PRODUCT DISCONTINUATION

#PD-IFC-9M7B-16

HEAVYCON's original B-Series screw termination contact inserts will be discontinued and replaced with a significantly improved version. Benefits of the new design include:

Previous Product	(if applicable)	New Product

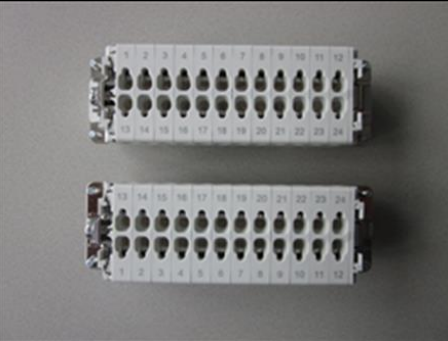
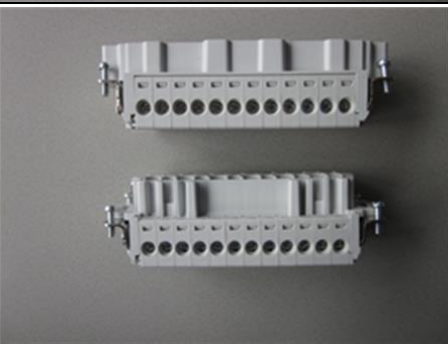
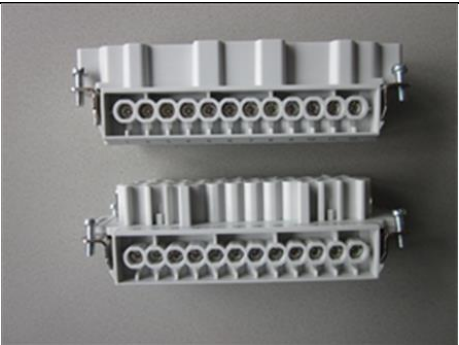
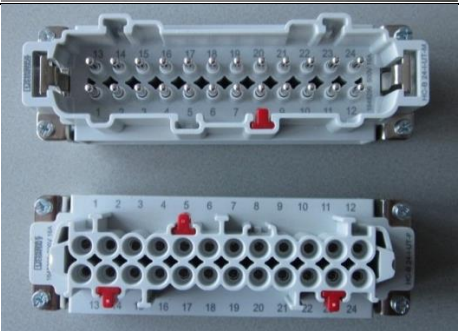
- Improved test points up to a 2 mm test pin.
- Improved UL current values. Old UL(USR) / CUL(CNR) : 13 / 13 Amps.
New UL(USR) / CUL(CNR) : 16 / 14 Amps.
- Improved IEC current values. B6 and B10 inserts up to 24 Amps.
B16 and B24 inserts up to 20 Amps.
- Approved for railway vehicles. Now comply with DIN EN 45545-2 with the R22, R23 and R24 requirements set in the hazard level HL1, HL2 and HL3.
- Plastic material changed from glass fiber reinforced PA to industry standard glass fiber reinforced PC.
- New quick-connect coding pins (red tabs) provide fast mechanical keying to prevent identical hood and base connectors from being mis-mated.

All new contact inserts will be fully compatible with existing B-series inserts, both from Phoenix Contact as well as other suppliers.
